Service Information Letter

Units Affected: Certain AT30-G, AT37-G, AT37M, AT40-G, AT40M, AT41M, AT48M, AT48P, AT248F, AM50/55, TA50/60, L42E, LR7, DH50B, DM47B, and Service Bodies equipped with JEMS 4 and JEMS 6 systems (see attached list)

Battery Cell Low Voltage Repair

Figure 4 — JEMS 4 12V Supply Wire To C2

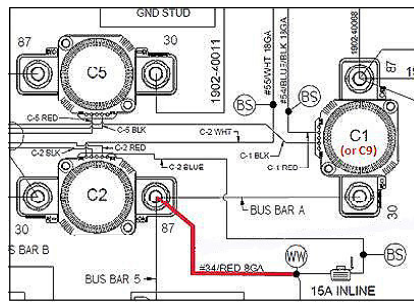
3. Remove the cover on the JEMS battery pack enclosure. Look to see to which contactor the red 8 GA 12V supply wire is connected.
 - If it is connected to the stud on contactor C2 (refer to Figure 4 or 5), proceed to Step 4 to perform the wiring modification.
 - If the wire is connected to the stud on contactor C1 may be labeled C9 on some JEMS 4 units (refer to Figure 6 or 7), the wiring has already been modified. Proceed to Step 11.

4. For the JEMS 4, move the red 8 GA 12V supply wire from C2 to C1 (or C9) according to ZeroRPM work instruction 4807-00133. For JEMS 6, move the red 8 GA 12V supply wire from C2 to C1 according to ZeroRPM work instruction 990263141.
